RANCHO MURIETA COMMUNITY SERVICES DISTRICT
Sacramento County, California

Bidding and Contract Documents
GRANLEES RAW WATER INTAKE IMPROVEMENTS PROJECT

ADDENDUM NO. 1
Issued March 18, 2024

PROPOSED IMPROVEMENTS FOR
GRANLEES RAW WATER PUMP STATION
ELECTRICAL CONTROLS
RANCHO MURIETA SACRAMENTO COUNTY, CALIFORNIA

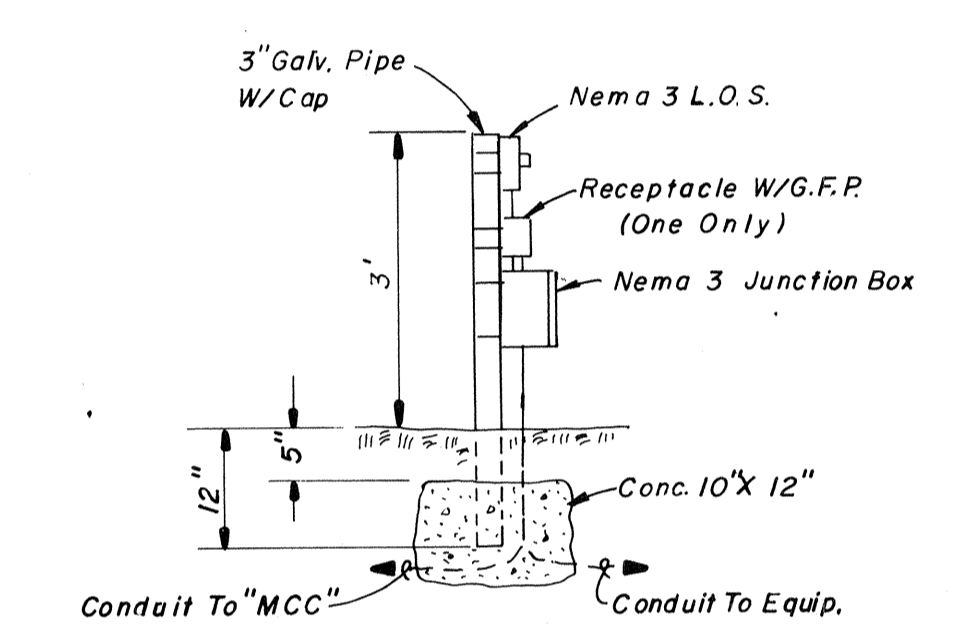
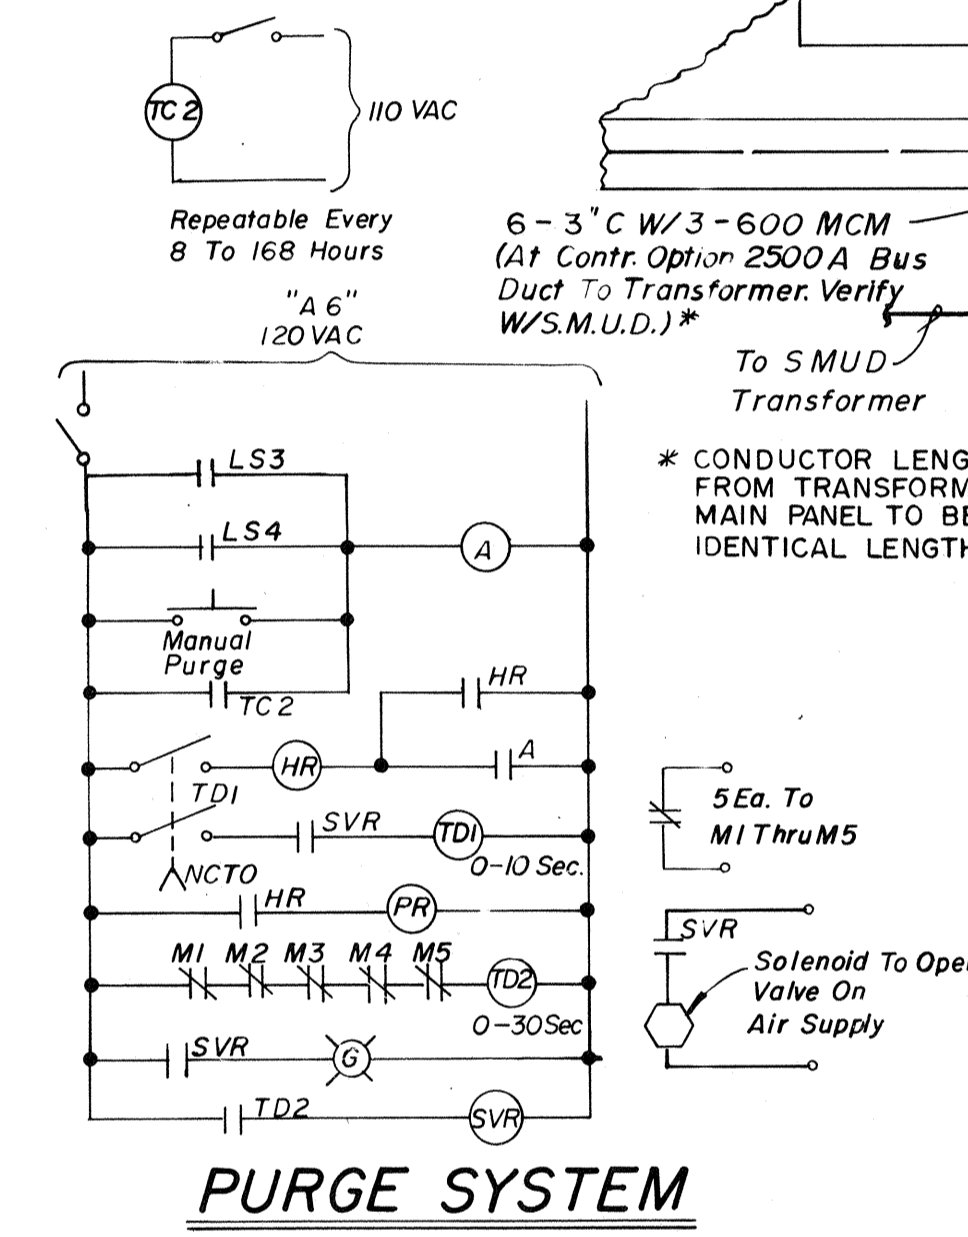
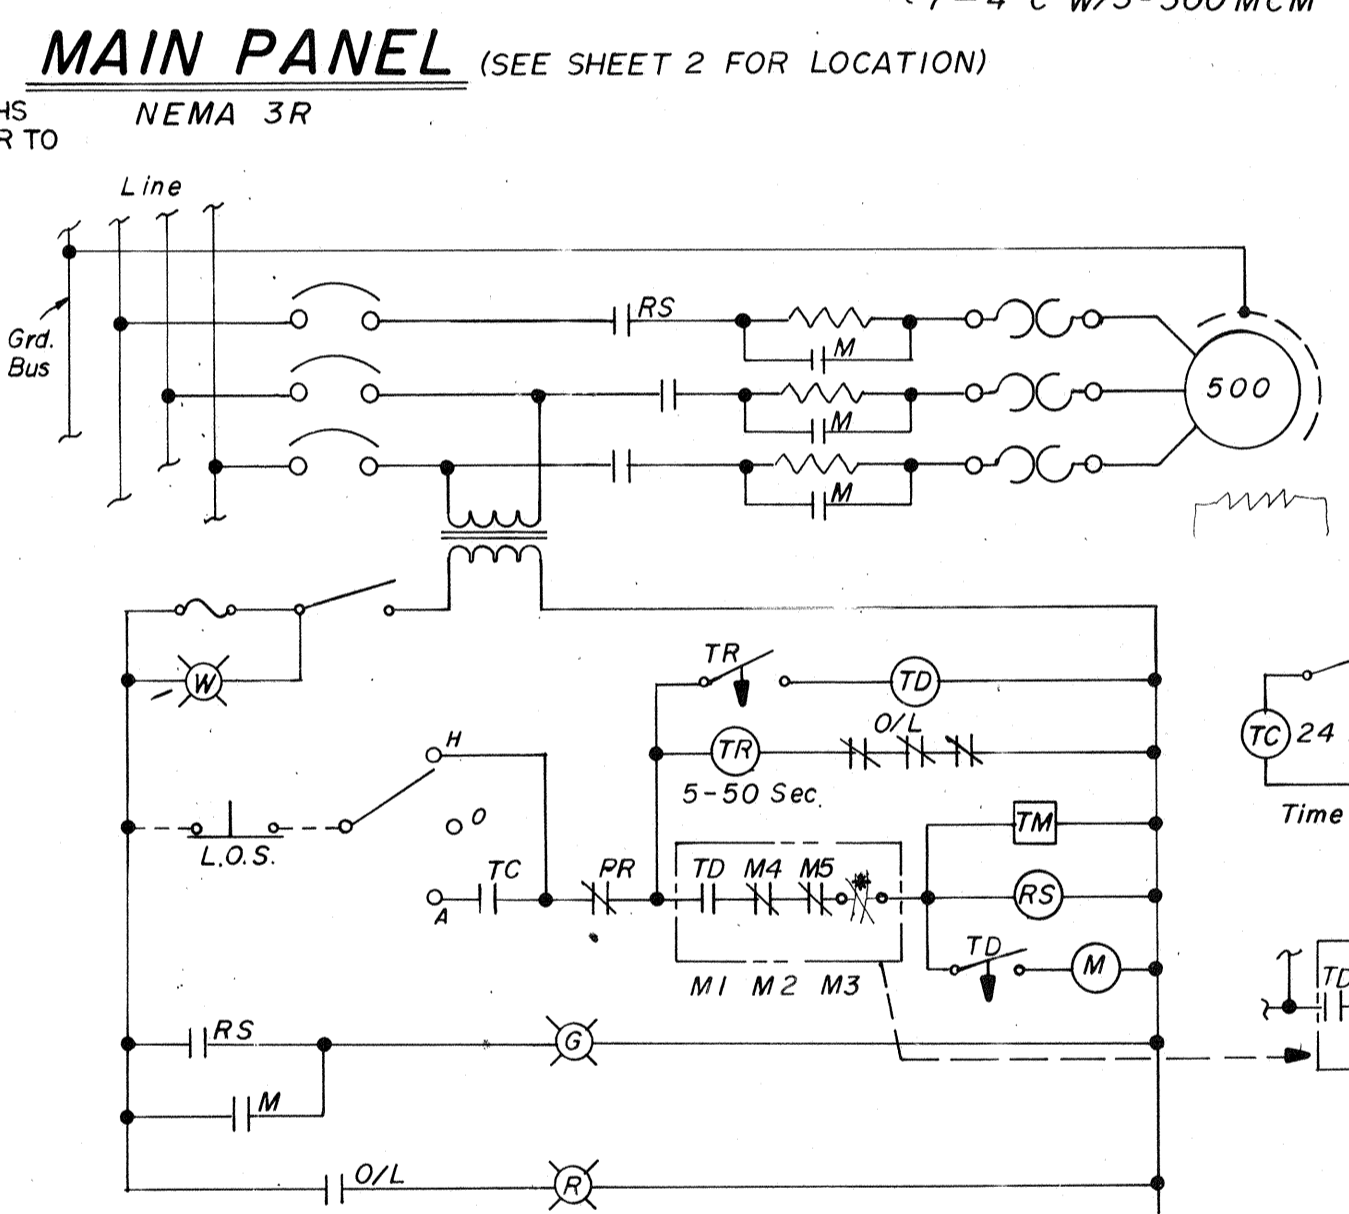
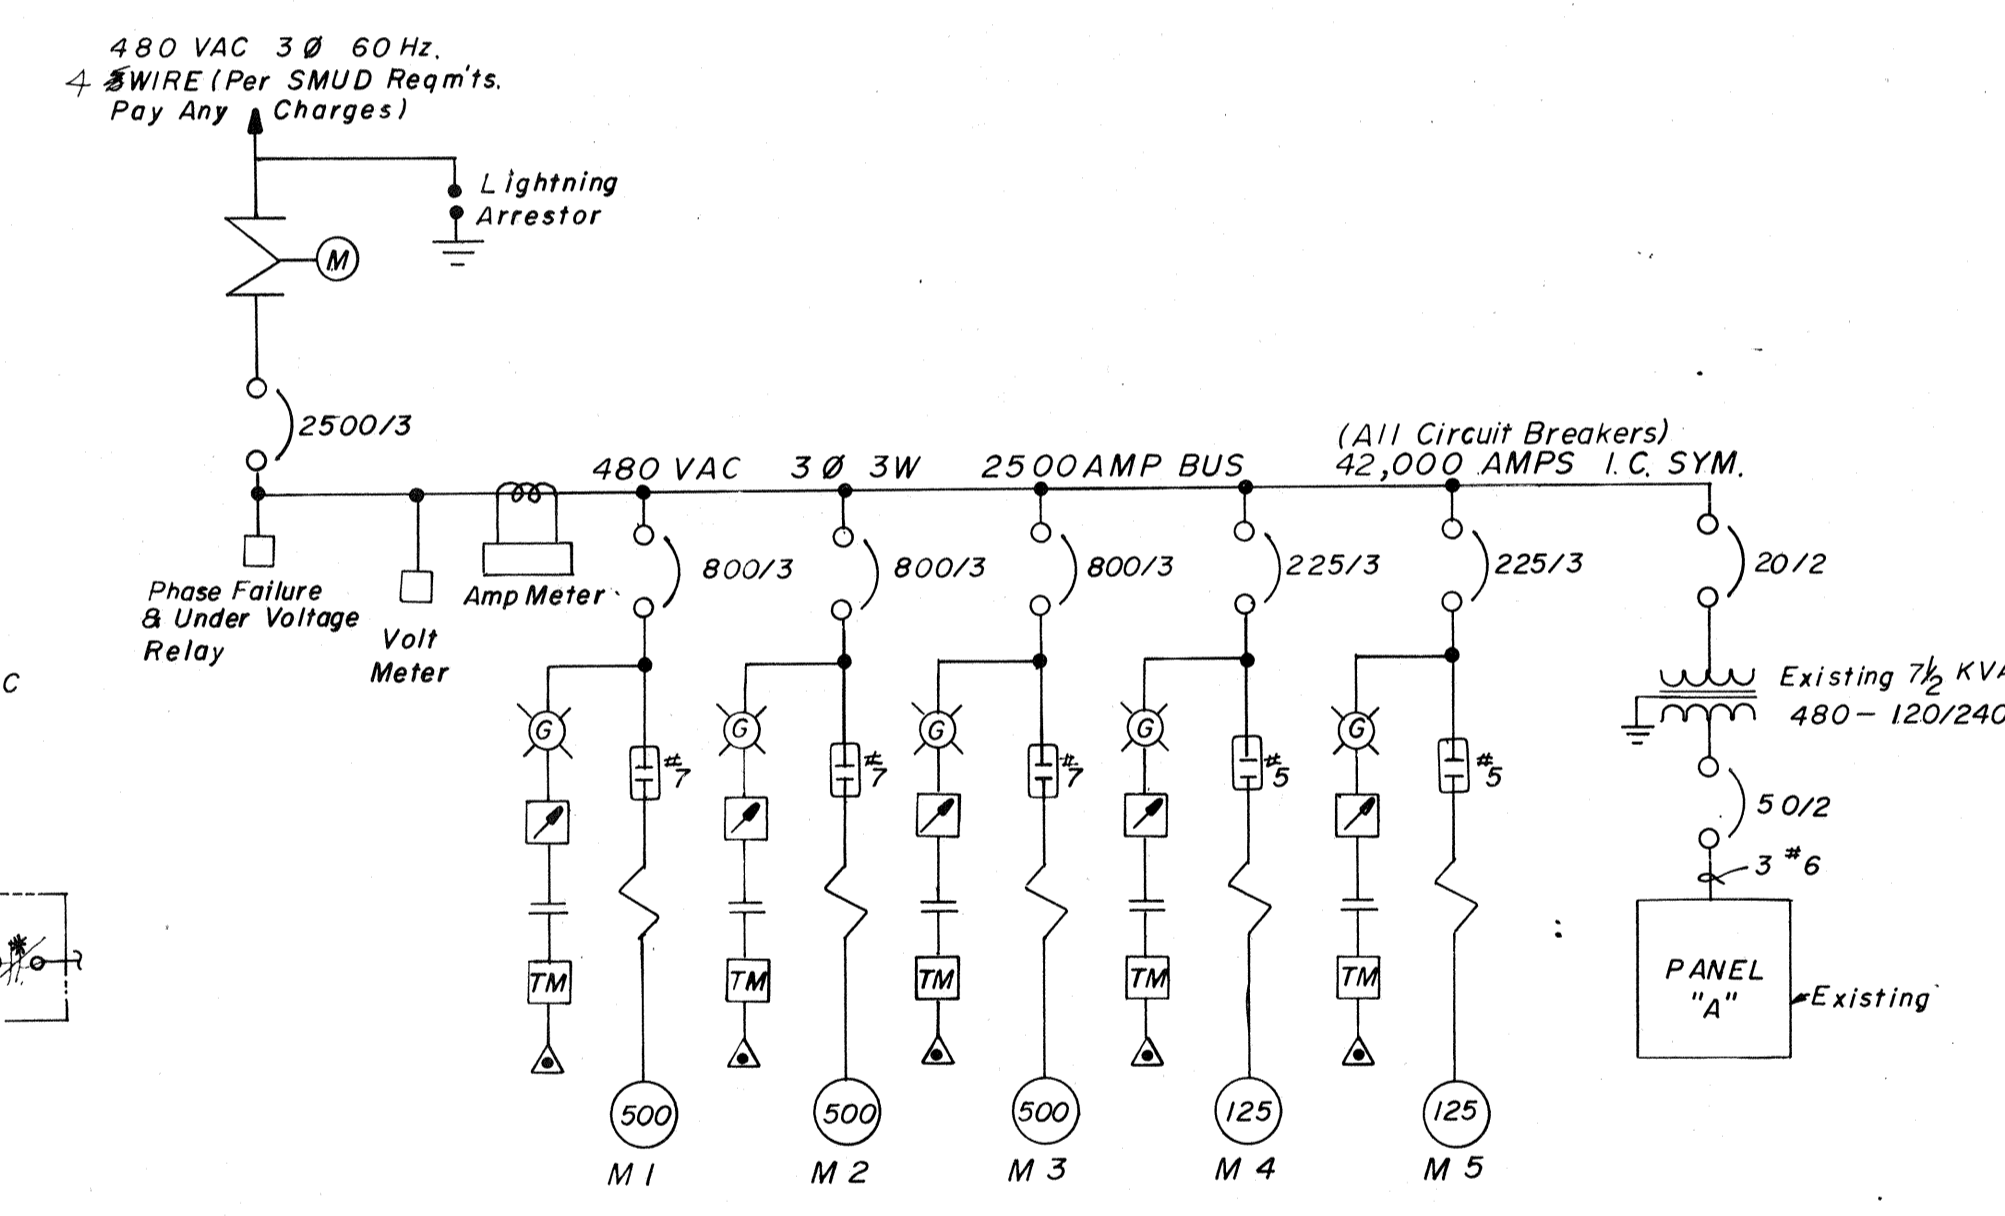
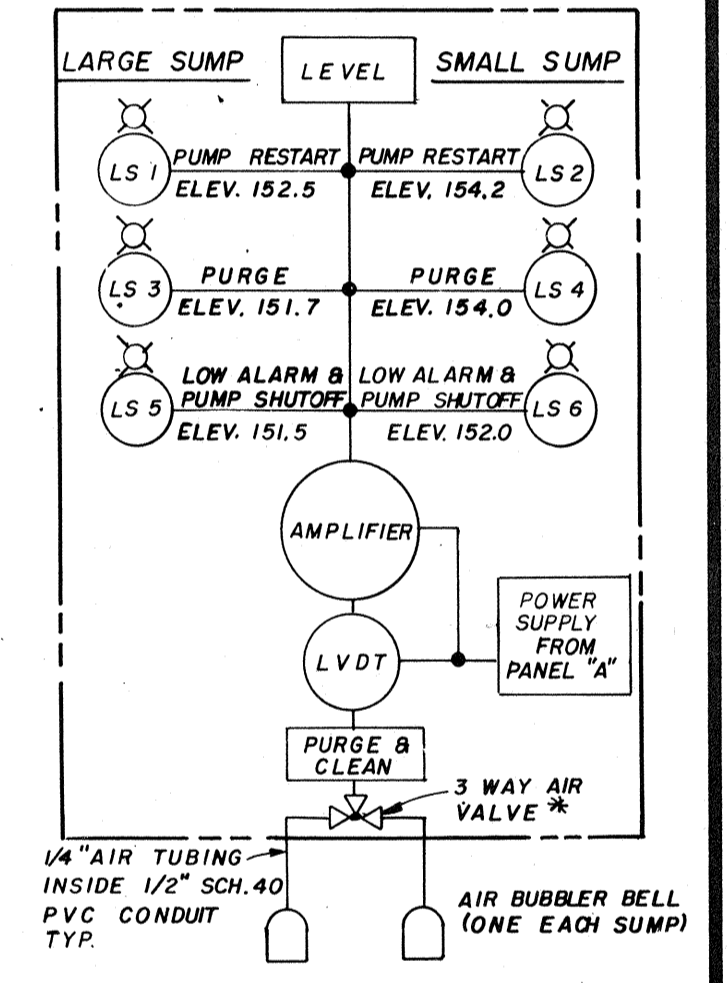
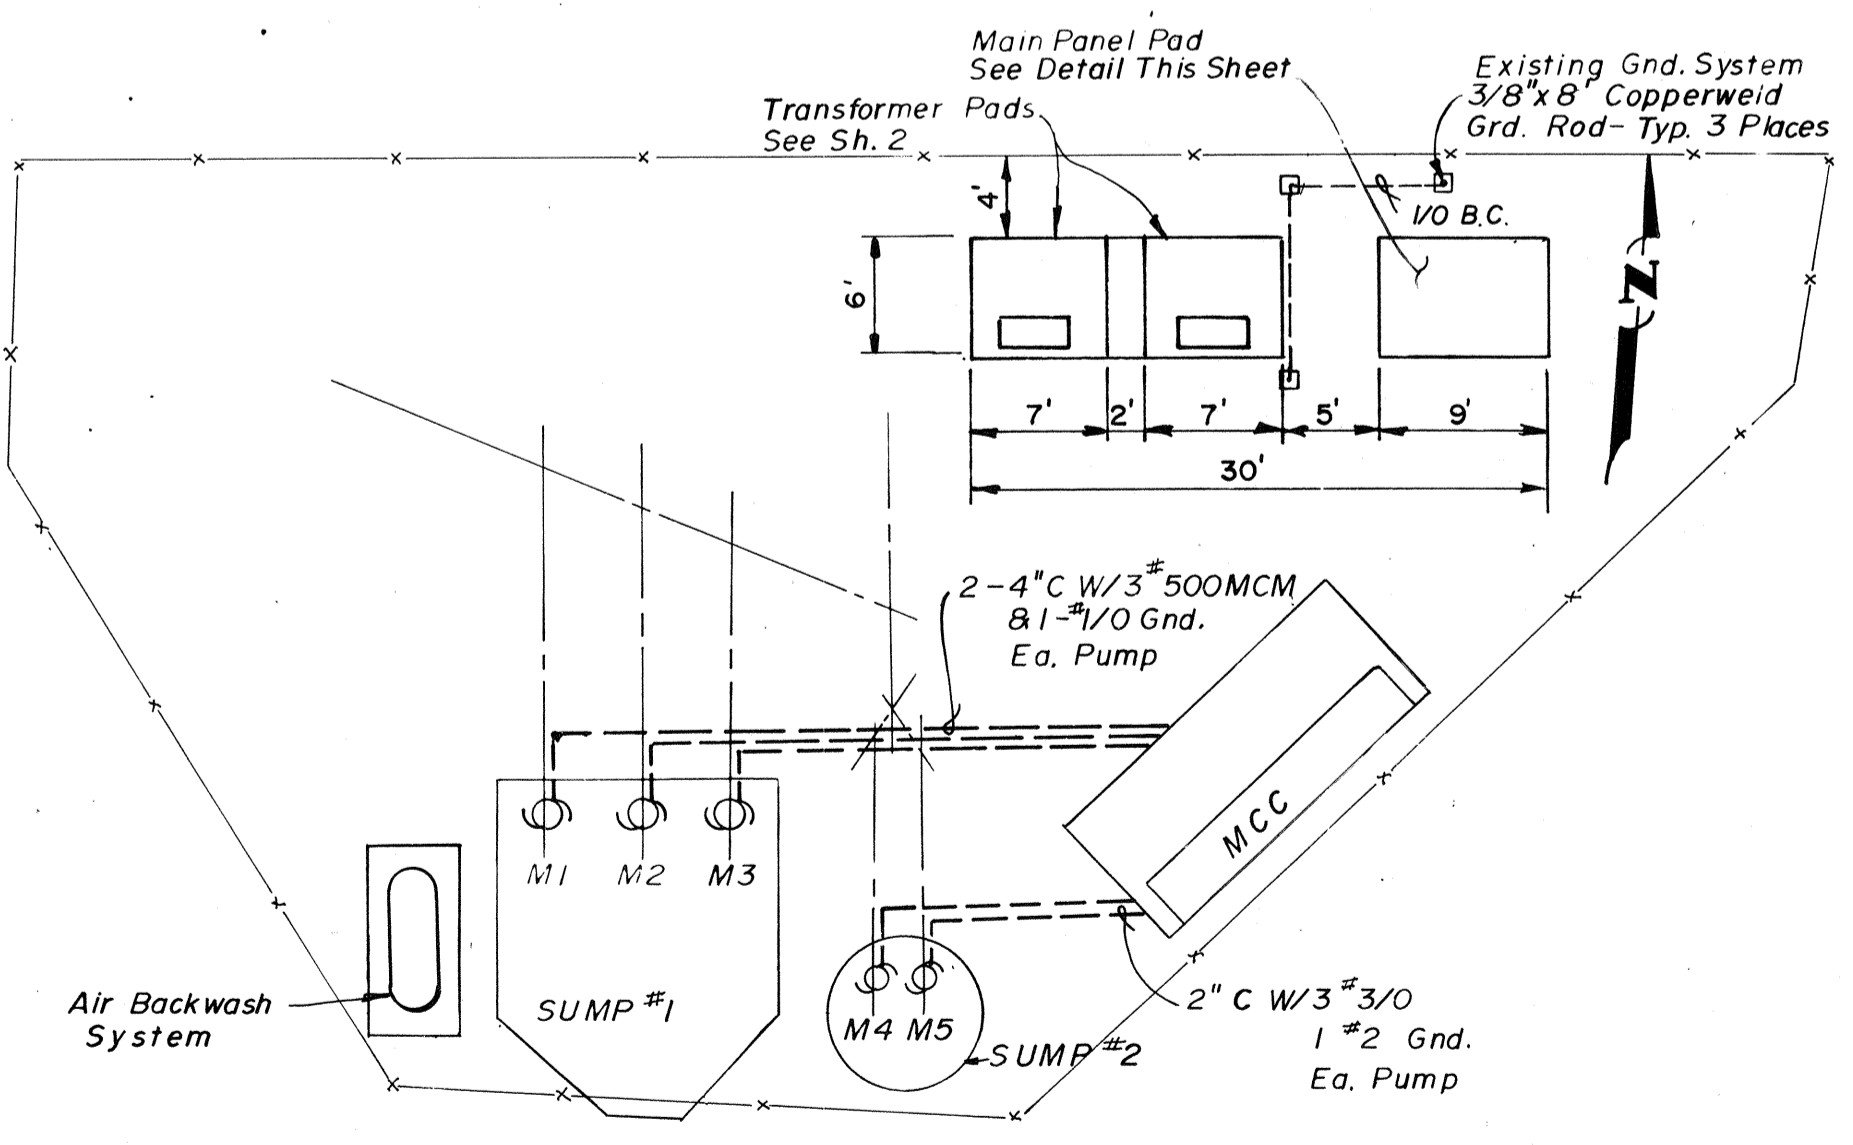
1. Will electric power be available for the bypass pumping and other construction activities, or does the contractor need to provide a generator?
 - a. Usability of electrical service from the Granlees pump station is at the discretion of the Contractor. Contractor shall submit electrical service plan for approval and furnish electrical service tie in from existing District pump panel and restore all portions of equipment and service to original condition prior to contract closeout. See attached electrical drawings for existing service.
